EXPLANATION OF SIGNIFICANT DIFFERENCES

ONONDAGA LAKE BOTTOM SUBSITE OF THE ONONDAGA LAKE SUPERFUND SITE

MODIFIED PROTECTIVE CAPS

March 2018

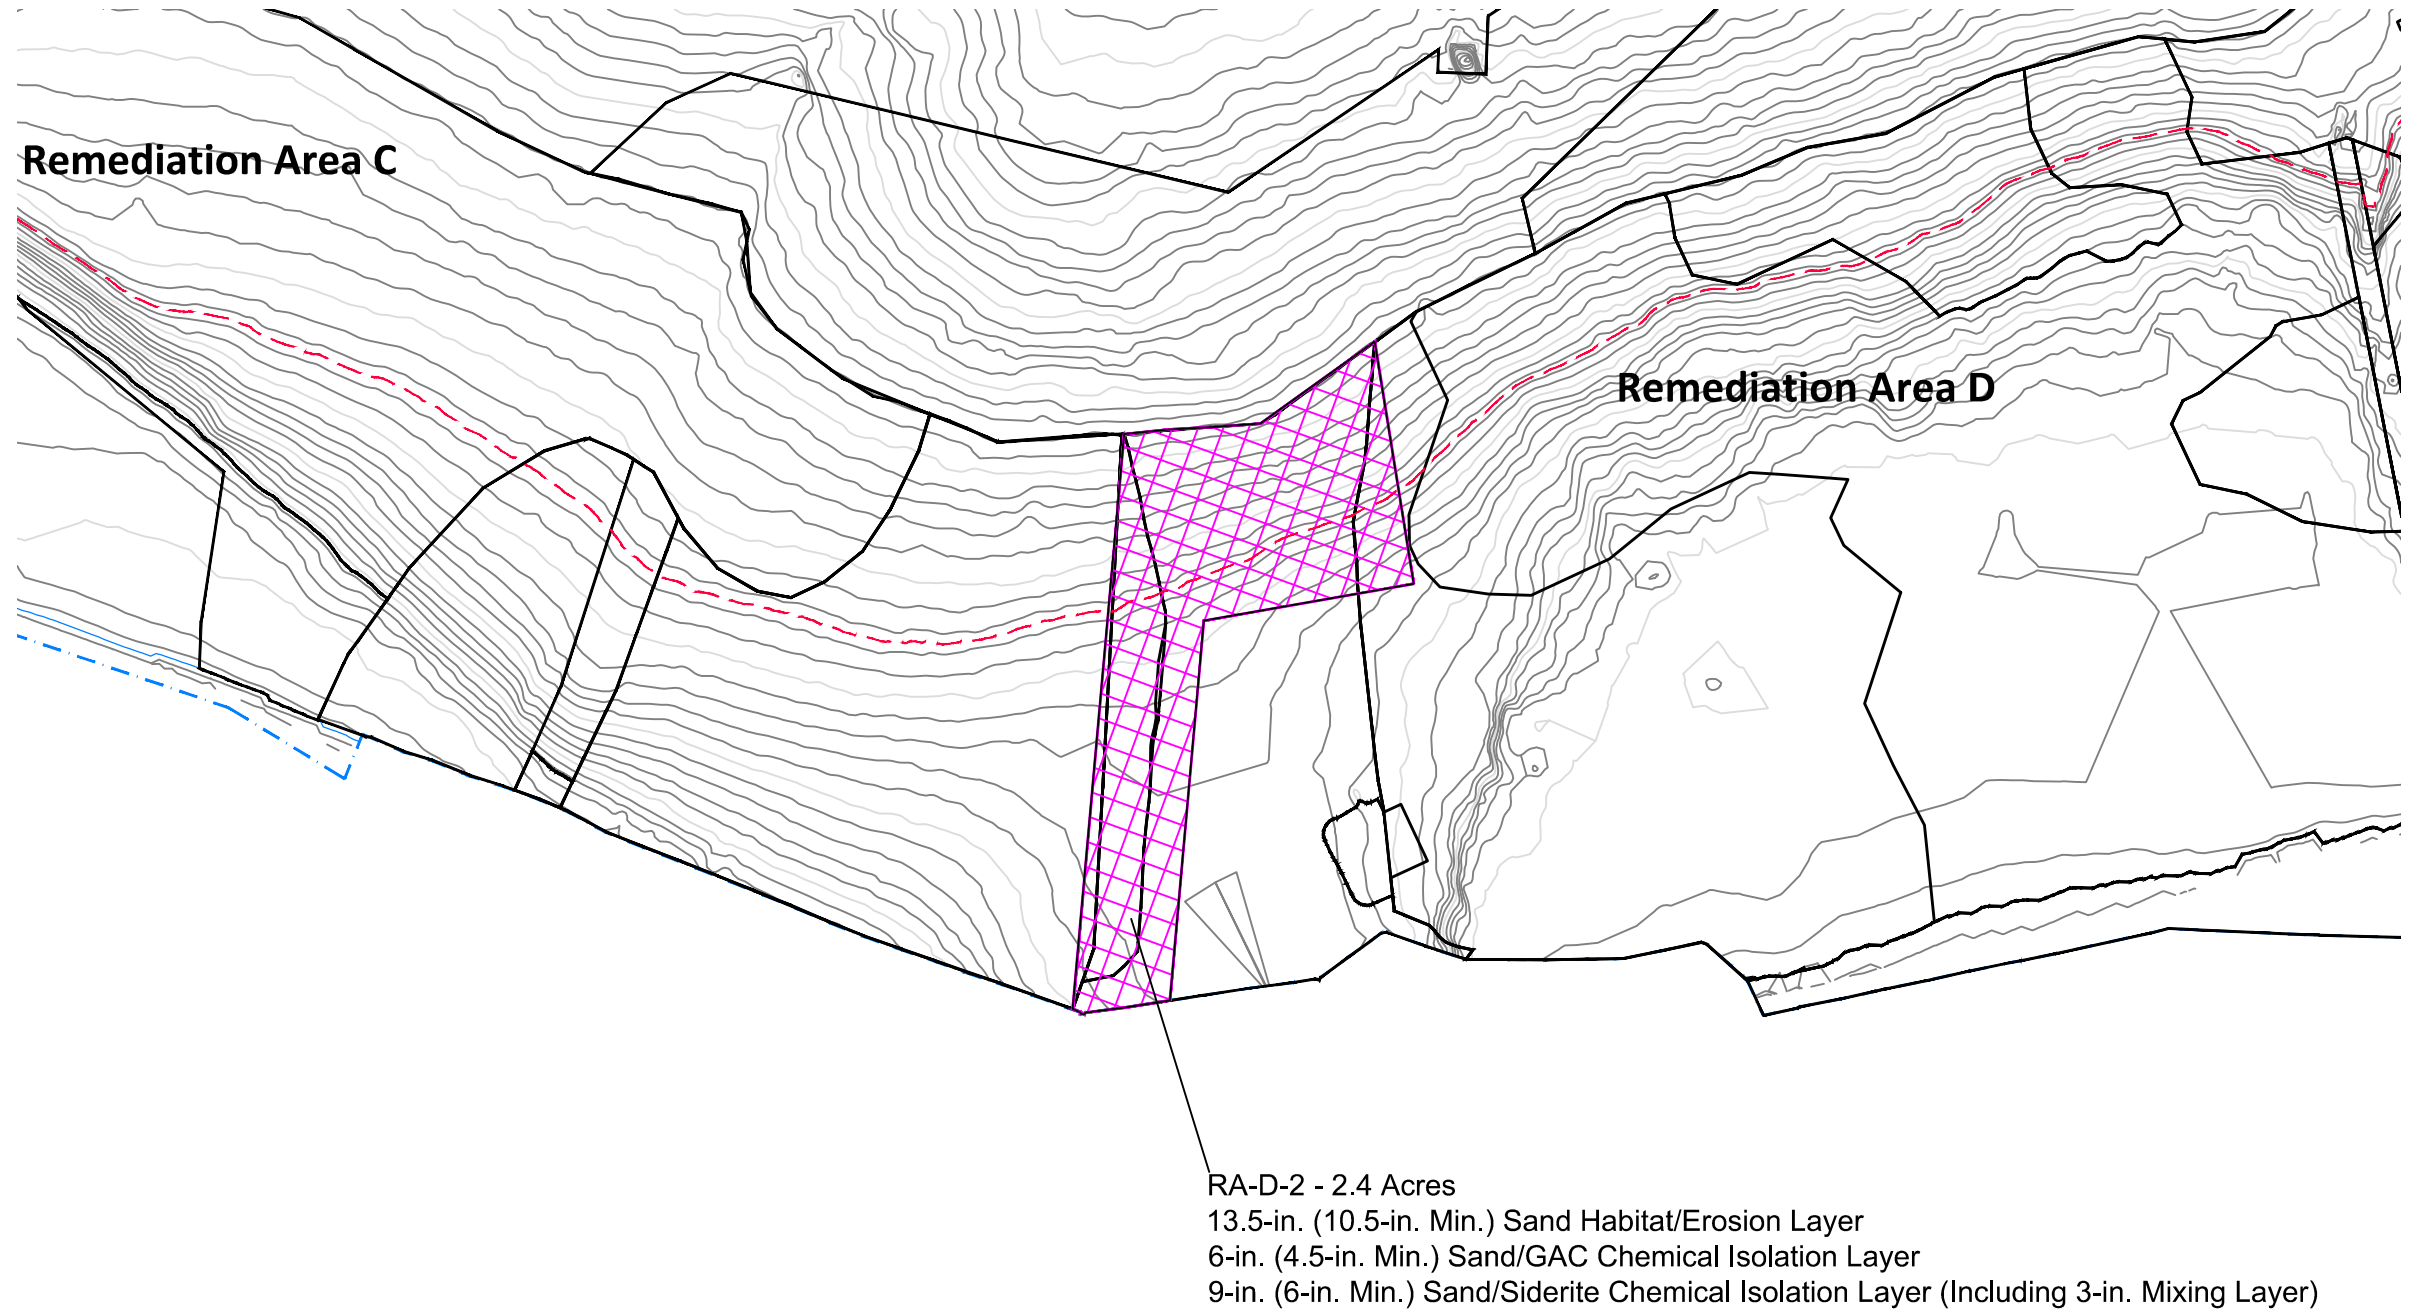
- **RA-D-2:** As shown in Figure 8 and presented in Table 1, approximately 2.4 acres of this MPC area consist of a multi-layer cap with a minimum 10.5-inch habitat/erosion protection layer and a reduced thickness isolation layer (less than the minimum of 12 inches).
